SERVICE BULLETIN

M-1325

2012 VOLTAGE REGULATORS - PRODUCT PROGRAM 0912

Figure 1. Date Code Location

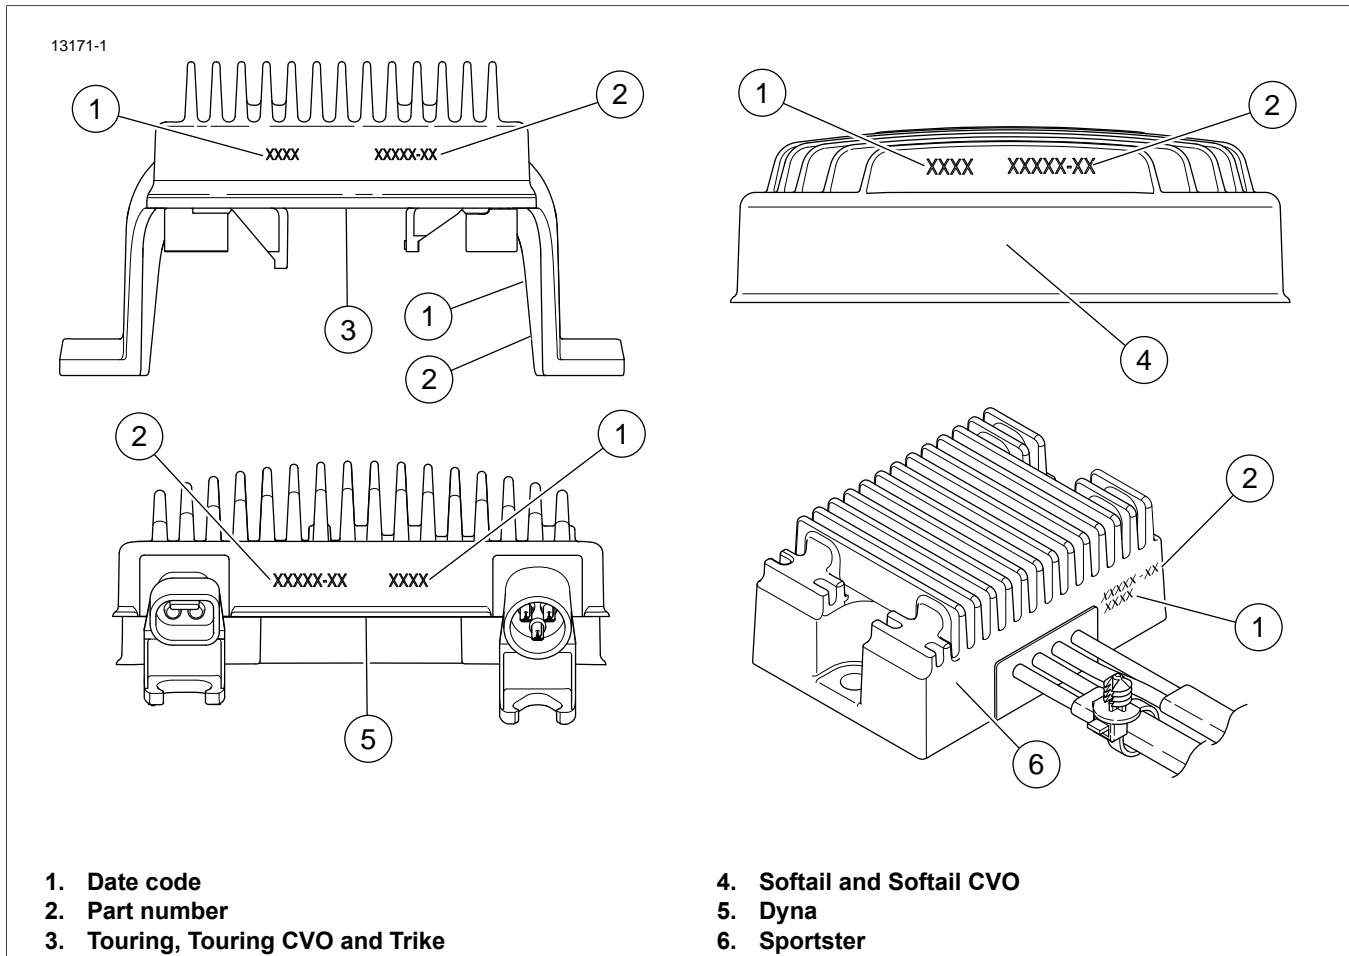
- See Figure 1. The voltage regulator date code (1) is in a four digit format. The first two digits are the week number of the year. The second two digits are the year. For example 4011 is the date code for October 3, 2011 through October 9, 2011.

- Refer to Table 2. Replace voltage regulator if the date code on voltage regulator fall within date ranges in table. See the service manual for removal and installation procedures.

4011-5211
0112-0912
